Document 00910

ADDENDUM NO. Date of Addendum: \(\square\frac{\pi_{\infty}}{20} \)

PROJECT NAME: Almeda Road Paving and Drainage Improvements Old Spanish Trail to South MacGregor Way PROJECT NO: WBS No. N-000806-0001-4; CSJ No. 0912-72-072 BID DATE: May 28, 2015 J. Timothy Lincoln, P.E., City Engineer FROM:

TO: **Prospective Bidders**

SHEET 2 OF
WBS NUMBER	FOR CITY OF HOUSTON USE ON
N-000806-0001-4	
DRAWING SCALE	
VERT: AS NOTED HORZ: AS NOTED	
CITY OF HOUSTON PM	
MICHELLE RANDON, P.E.	
SHEET NO.22A OF 271

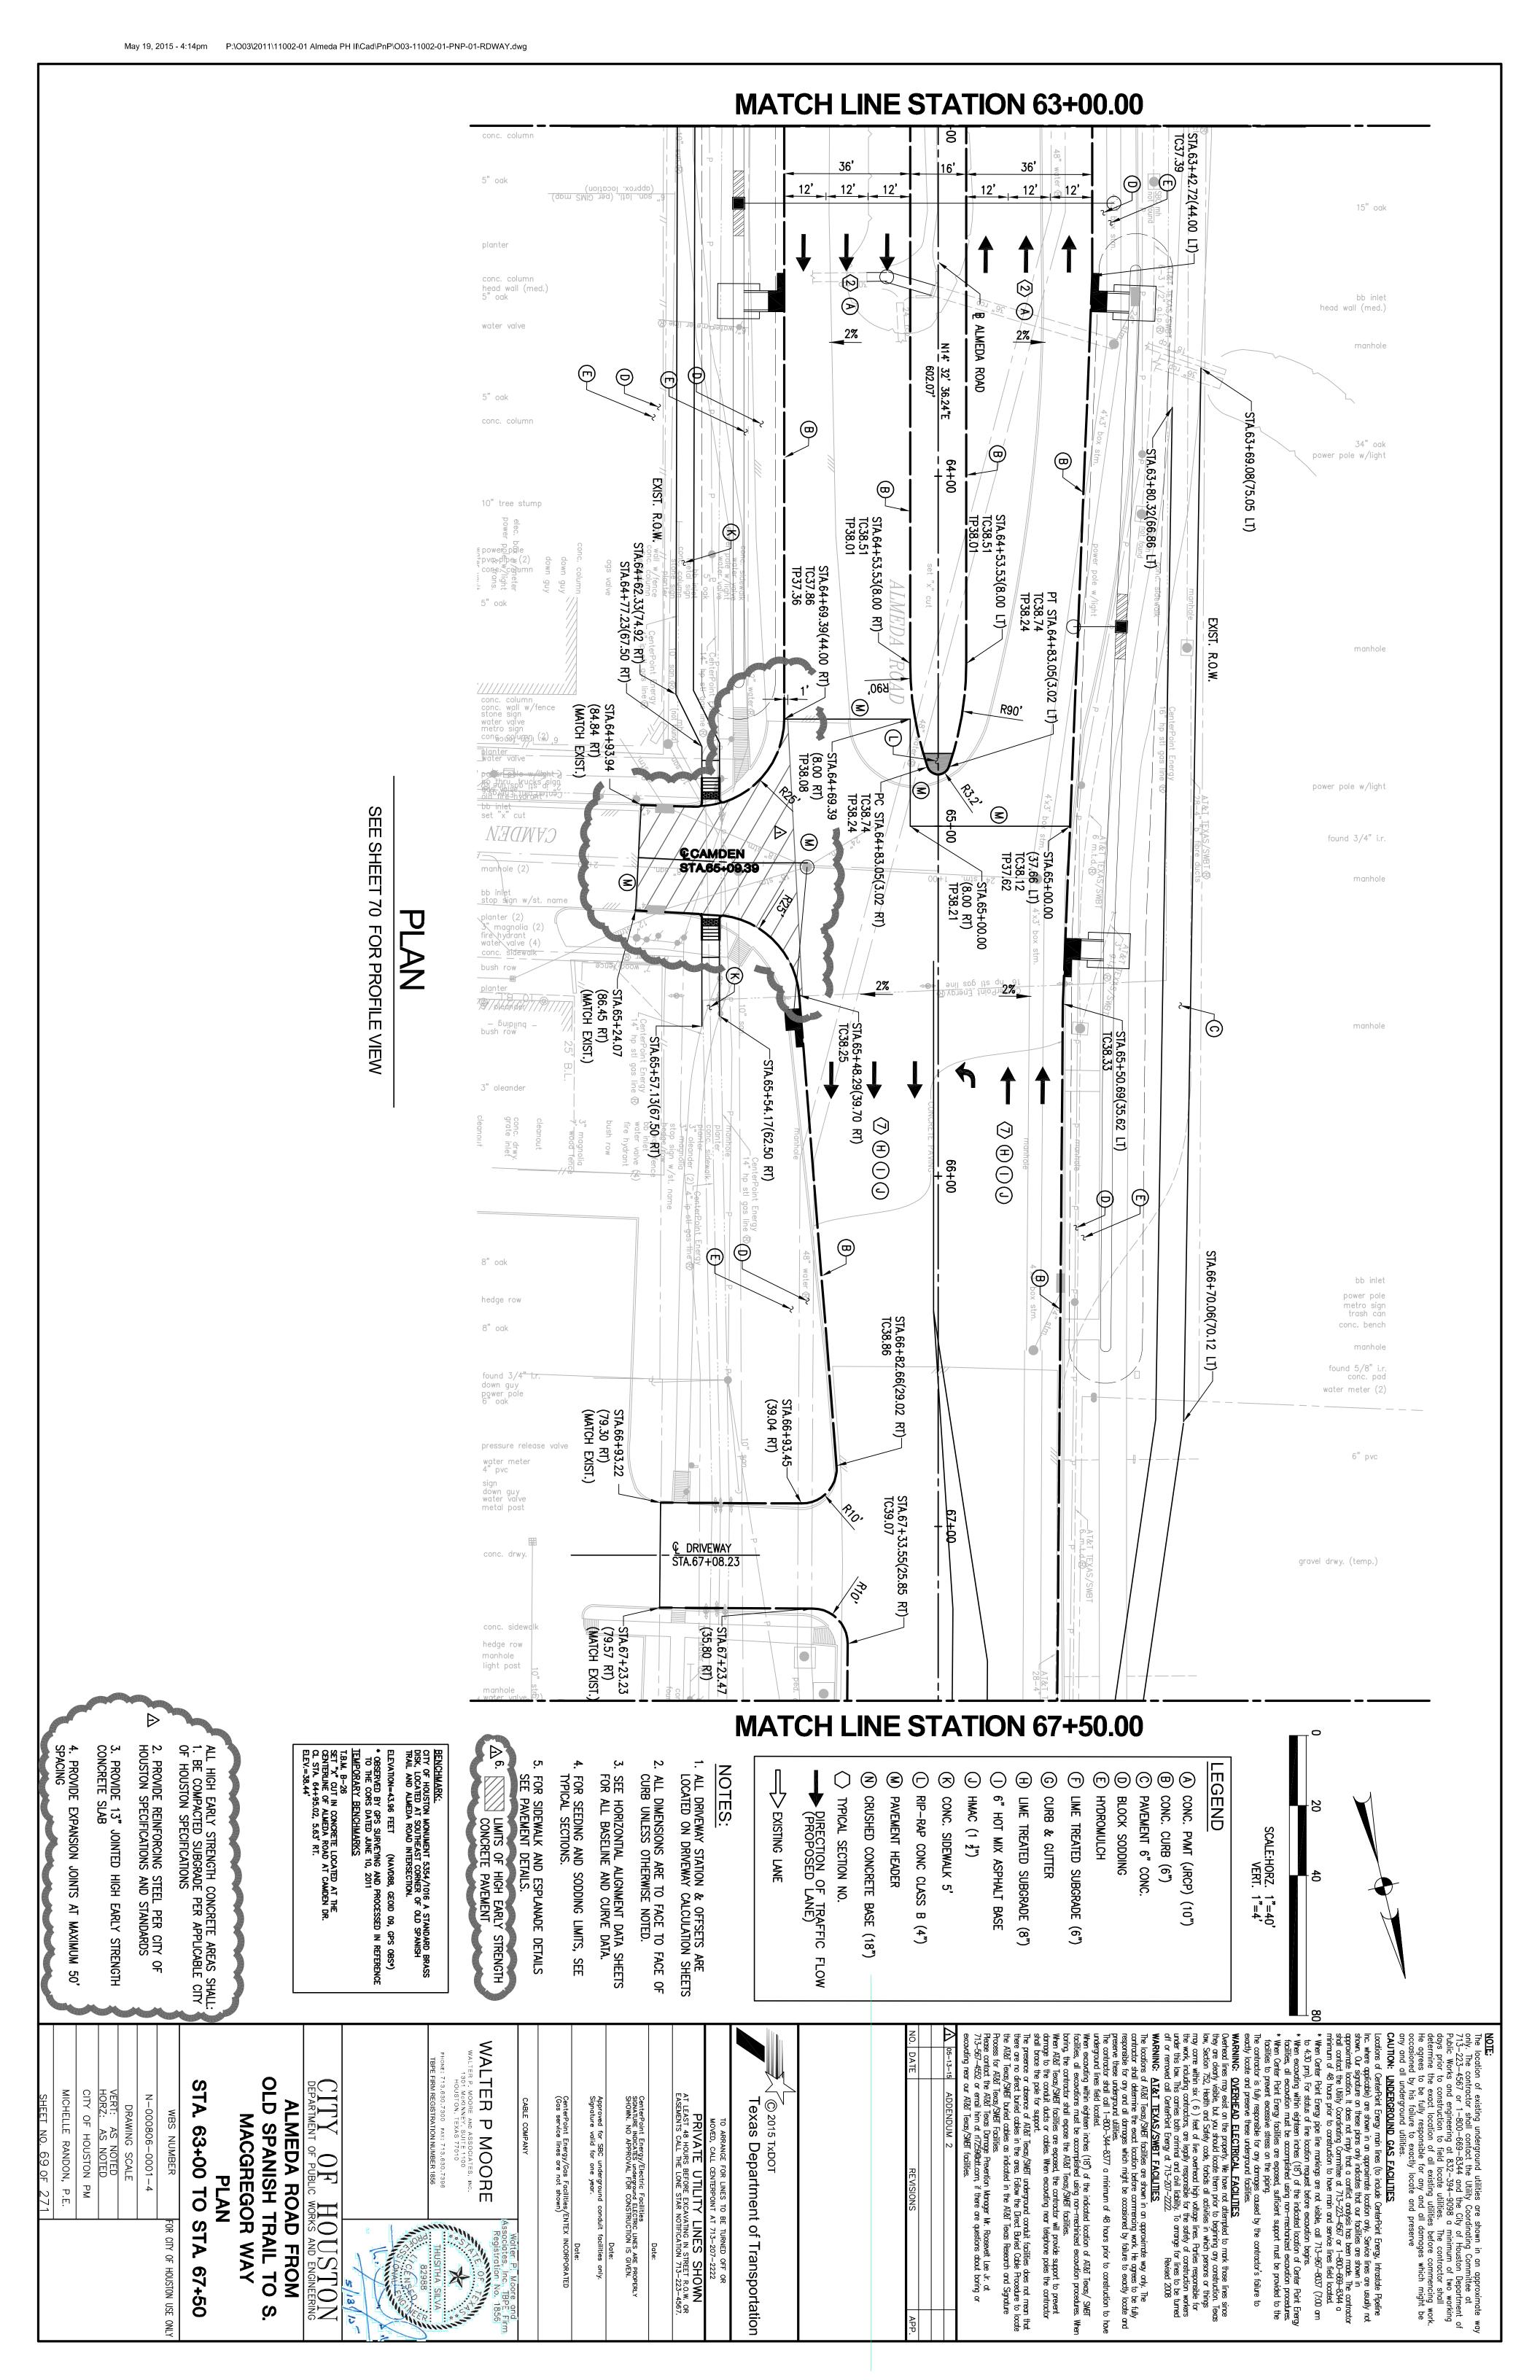
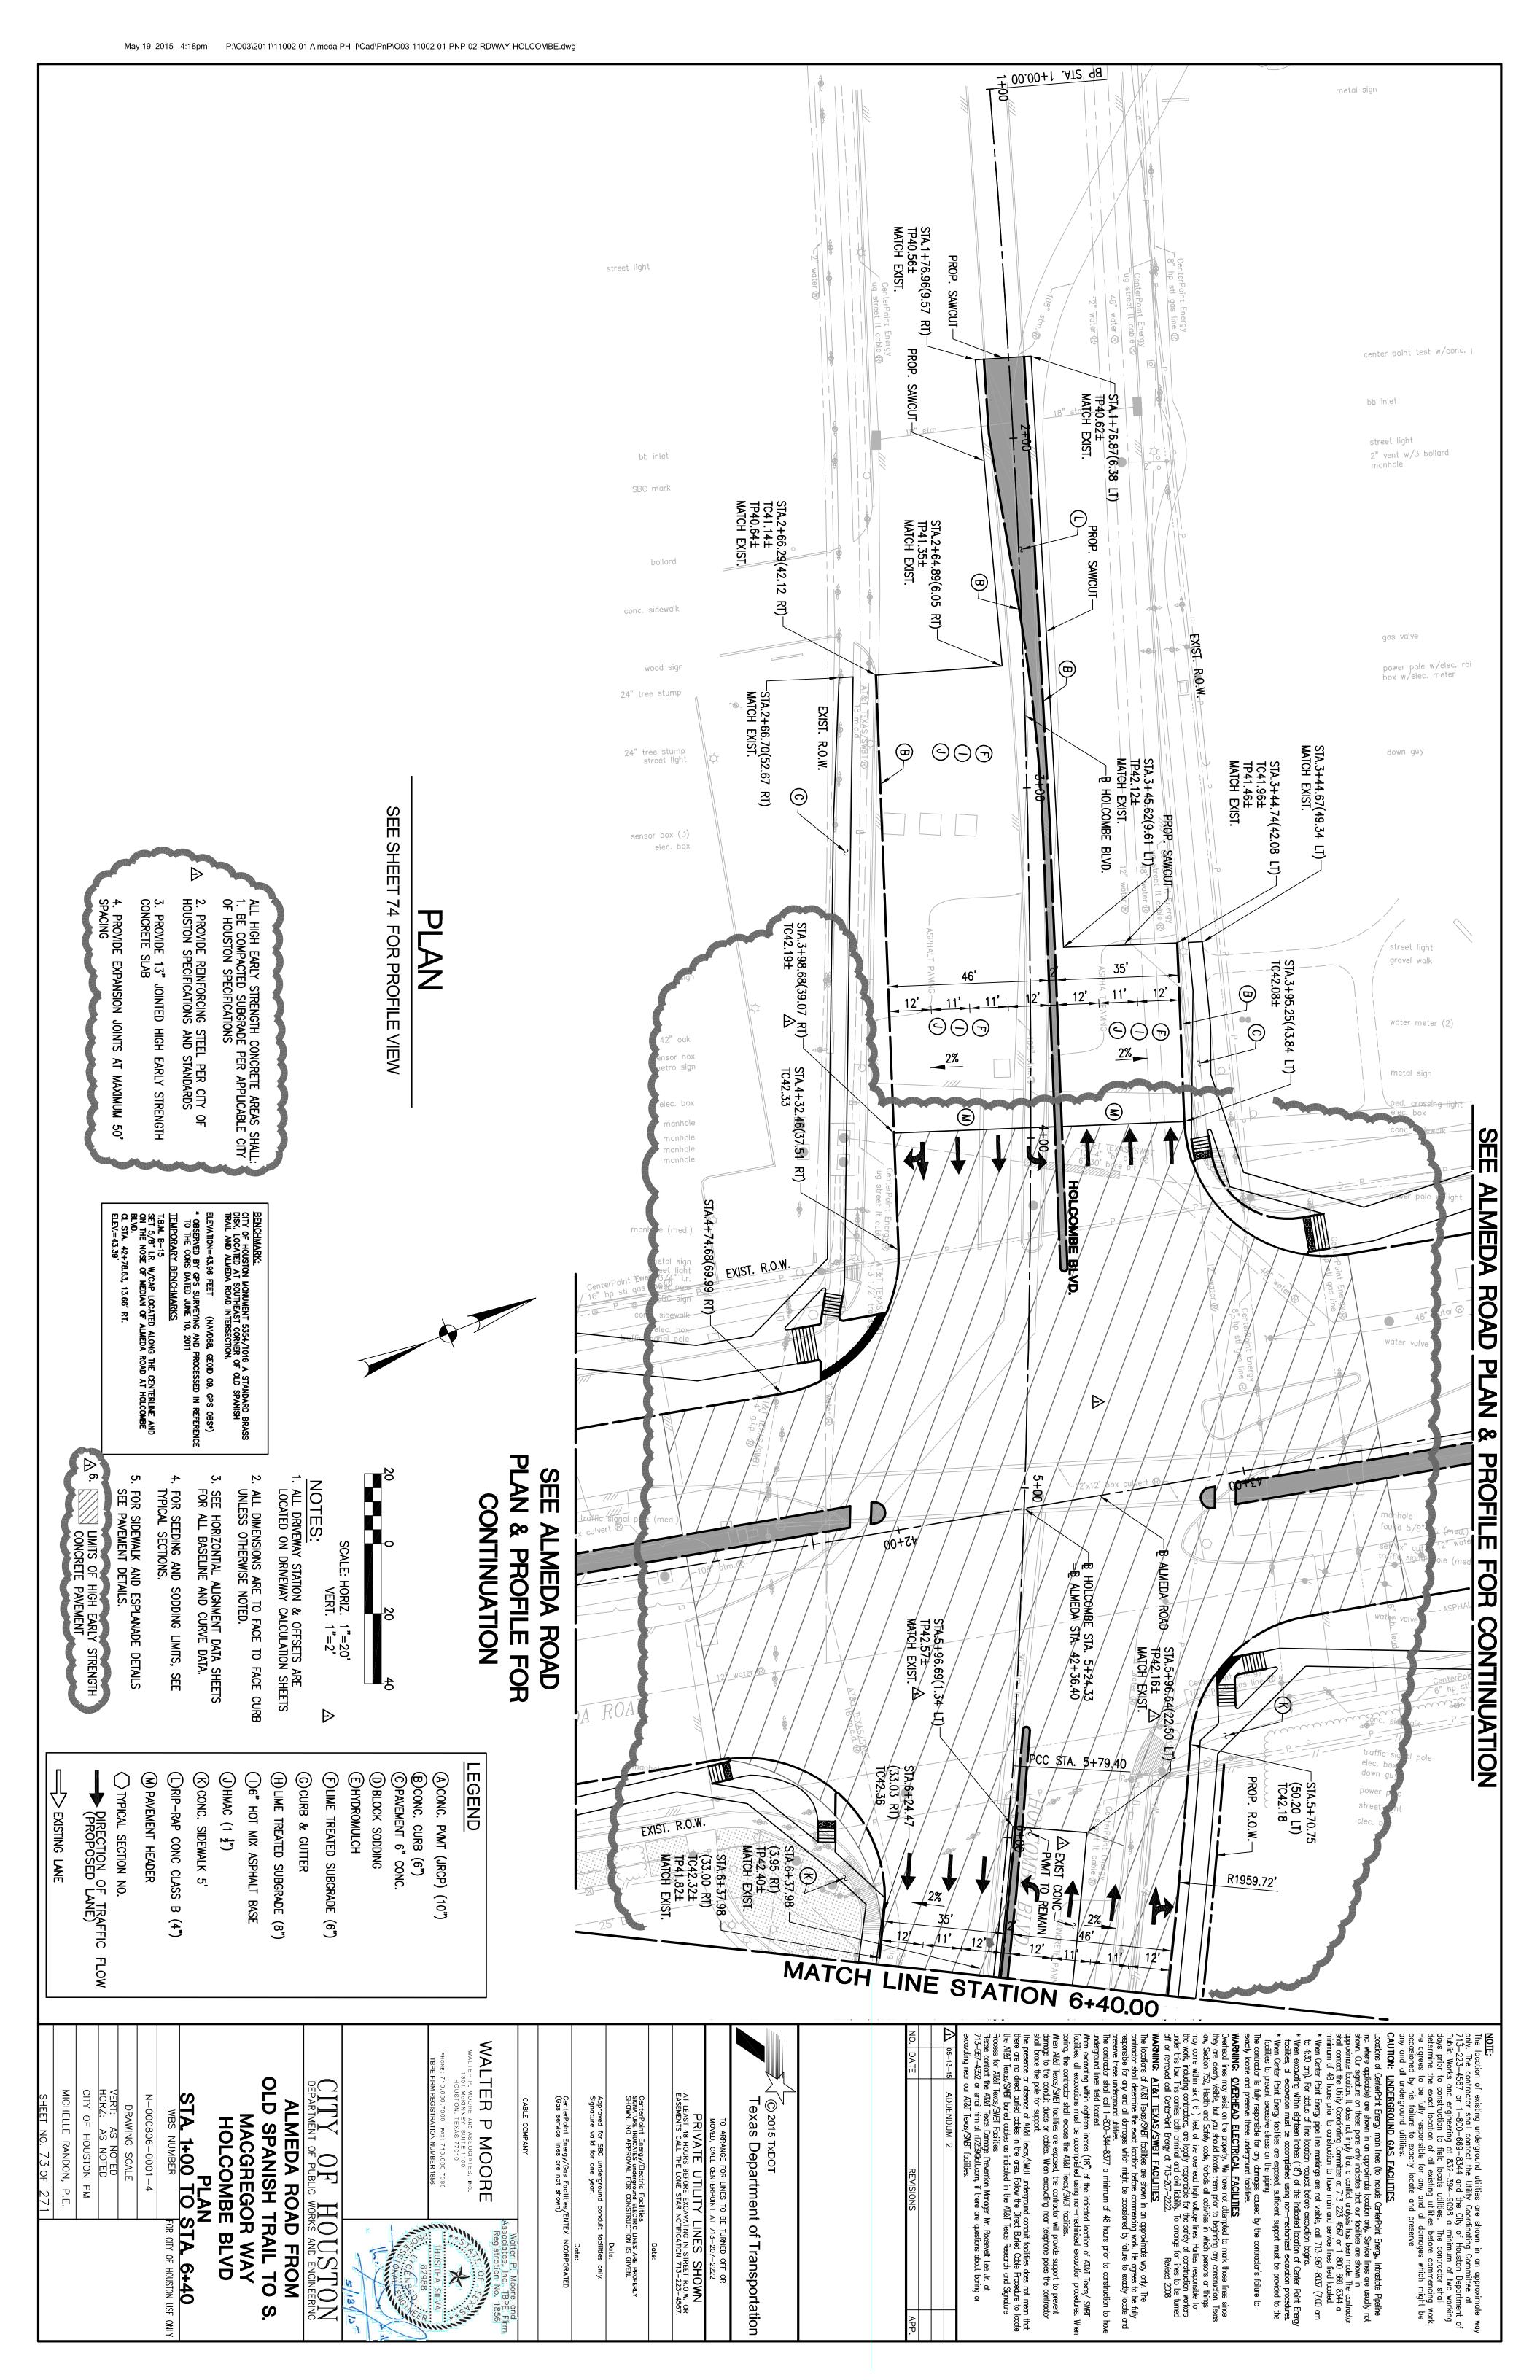
- 1. Sheet 21- Revised Holcombe Boulevard typical section, STA 6+37.98 to END PROJECT, to reflect added pavement and sidewalk reconstruction.
- 2. Sheet 22 Revised DEMOLITION QUANTITY.
- Sheet 22 A Revised STORM SEWER & STREET & BRIDGE QUANTITY
- 4. Sheet 47 Added driveway at station 16+04.59 & added shaded area to reflect limits of High Early Strength Concrete placement limits.
